RE: WR Order 2007-0015 DWR

This letter is in response to the May 10, 2007 Notice of State Water Resources Control Board Order Approving a Temporary Urgency Change Petition by Sonoma County Water Agency Regarding Permits 12947A, 12949, 12950 and 16596 ("the Order"). The need to conserve storage in Lake Mendocino, ensuring a minimal flow in the upper Russian River through October 2007, thereby avoiding severe impacts to the Chinook Salmon fishery, Lake recreation and water users that rely on Lake Mendocino and the upper Russian River, is apparent. However, given the urgent nature of this Petition and the potential for a multi-year drought in California, the measures in the May 10, 2007 Order are not sufficient. With the high potential for a multi-year drought, the SCWA must be looking past the end of this year to the future needs of Lake Mendocino, the upper Russian River, and its customers. In addition impacts to recreation, juvenile steelhead habitat and community well systems do occur and achieving conservation goals can partially mitigate those impacts. We thereby request the State Water Resources Control Board ("SWRCB") re-draft the Order to include mandatory water conservation

RUSSIAN RIVER NEAR HACIENDA BRIDGE  
FLOW, RIVER DISCHARGE

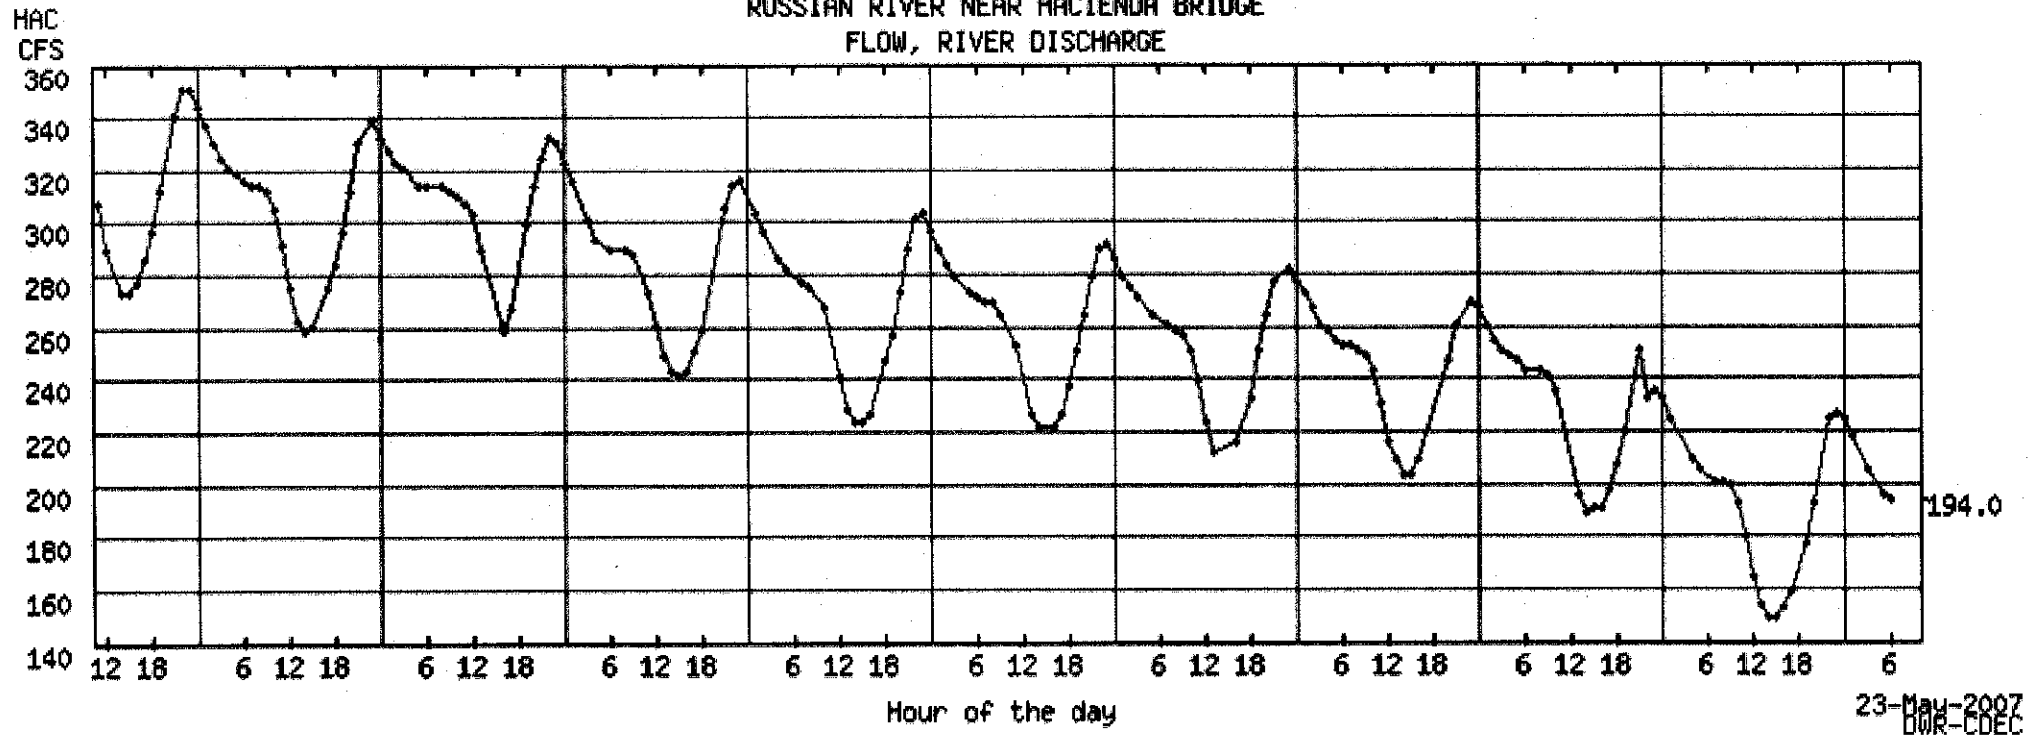
During parts of 8 days in August of 2004 Russian River flows at the USGS Hacienda gauge were below the 85 cfs instantaneous threshold in Order 2004-0035 and caused severe impacts to boat passage over riffles. According to Burke's Canoe Trips they have to give refunds to many customers who were dissatisfied by the constant getting out and dragging required between Forestville and Guerneville. The Sonoma County Sheriff's River patrol boat became stranded one day due to low water. From our own observations canoe passage is impaired at roughly 90cfs. These are real impacts that can be significantly reduced by conservation. During the excursions below 85cfs in 2004 as seen on the hourly cfs readings at Hacienda by CDEC (not provisional) we can see that pumping by SCWA at the Forestville wells depleted the operating margin of 50cfs. Looking at the Hacienda gauge readings in the attached May 2007 Hacienda gauge readings a roughly 65 cfs a day pumping signature is apparent although this is provisional data the curve is an accurate representation of the flow reduction caused by SCWA pumping. Our point in mentioning this data is that mandatory conservation can reduce the size of the cfs drop by a significant amount on those critical warm days and thereby leave more water for lower River users. We also would like consideration of revising provision 1.b to include the language from the 2004 order that a 5-day average of 100cfs be maintained.
